### **Amendments to the Drawings**

## REMARKS

FIG. 3

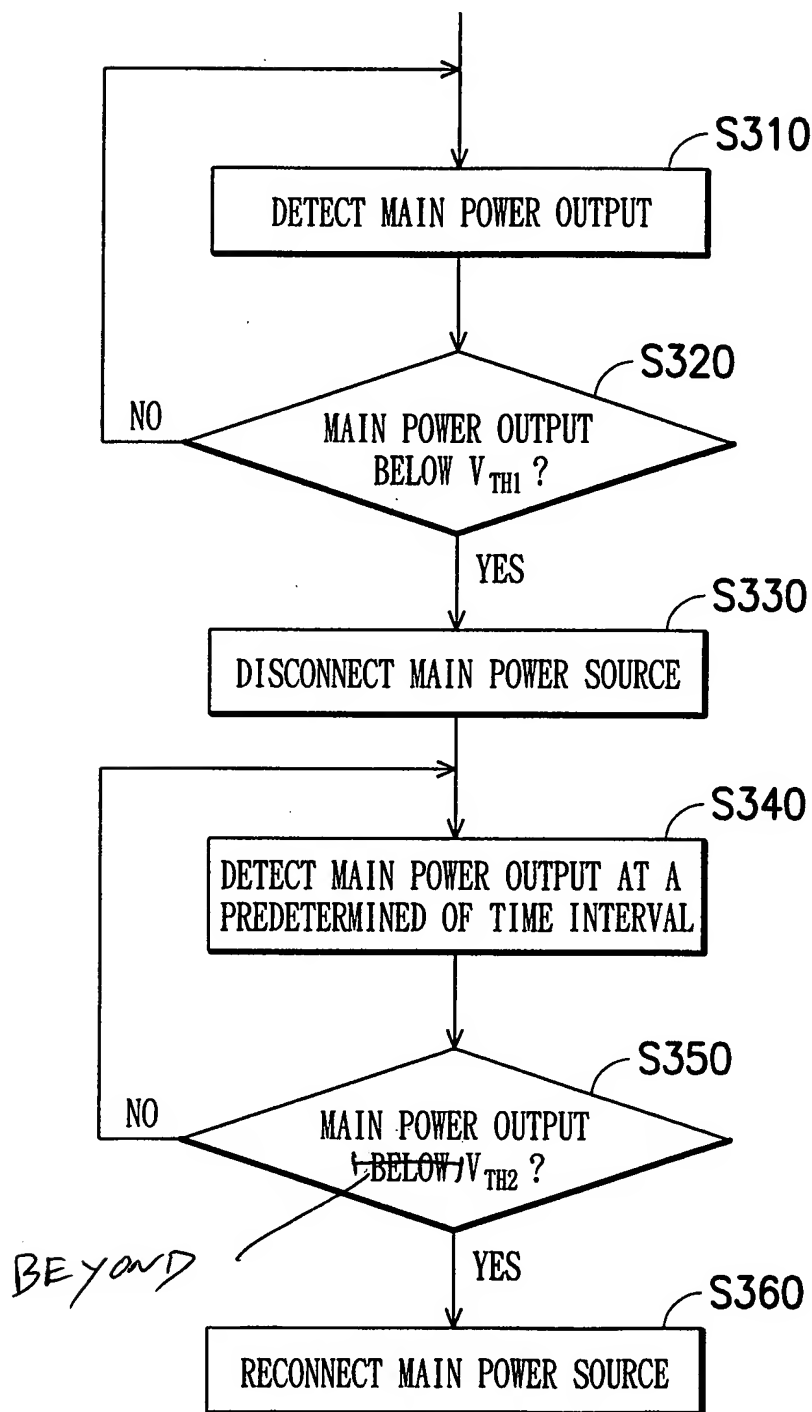
The attached sheet of drawings include proposed changes to Fig. 3 and replace original sheet 3 including Fig. 3. In Fig. 3, the text in step S350 has been corrected to recite: "MAIN POWER OUTPUT ~~BELOW~~ BEYOND  $V_{TH2}$ ".

Figure 3 of the drawings has been corrected for clarity purpose, by reciting for step S350: "MAIN POWER OUTPUT ~~BELOW~~ BEYOND  $V_{TH2}$ ?" in conformity with the language of paragraph [0016] of the specification. No new matter has been added.
